Index 700-020 Multi-Column Ground Sign

FY 2025-26
STANDARD PLANS

INDEX
700-020

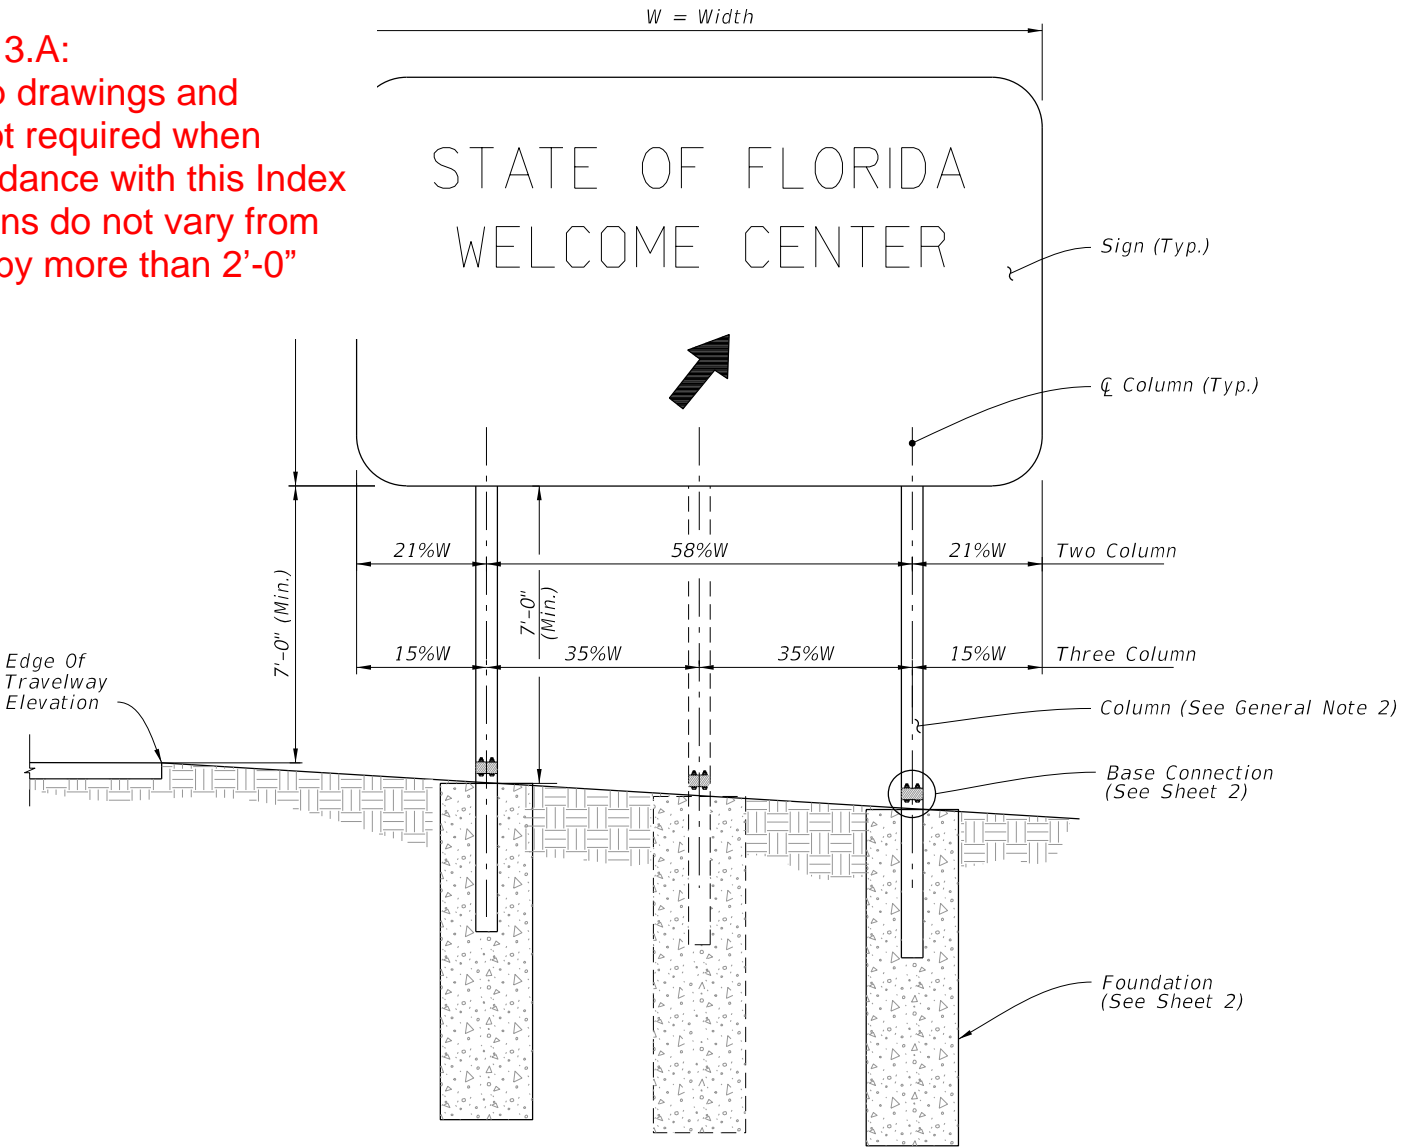
COMMENT: The draft proposes a tolerance of 2' on Note 3A on page 1 of 700-020.

Comment: This note may be modified to include the word "longitudinally", so it reads as:

"Sign Support Shop drawings and calculations are not required when fabricated in accordance with this Index and support columns do not vary from the plan locations by more than 2'-0" longitudinally".

- ~~A. Sign Support Shop drawings are not required when fabricated in accordance with this Index and support columns do not exceed the width ("W") shown in the plans by more than 2'-0".~~
- B. Sign Panels: Horizontal panel splices are allowed at interior wind beams for sign panels with a height ("H") greater than 10 feet. Shop drawings required for horizontal panel splice details.
- C. When shop drawings are required, obtain approval prior to fabrication.

RESPONSE: Agreed. We will add this clarification. Thank you for your comment!

CHANGE MADE TO INDEX: Yes, added "longitudinally" to the note.

CHANGED NOTE 3.A:
Sign Support Shop drawings and calculations are not required when fabricated in accordance with this Index and support columns do not vary from the plan locations by more than 2'-0" longitudinally.
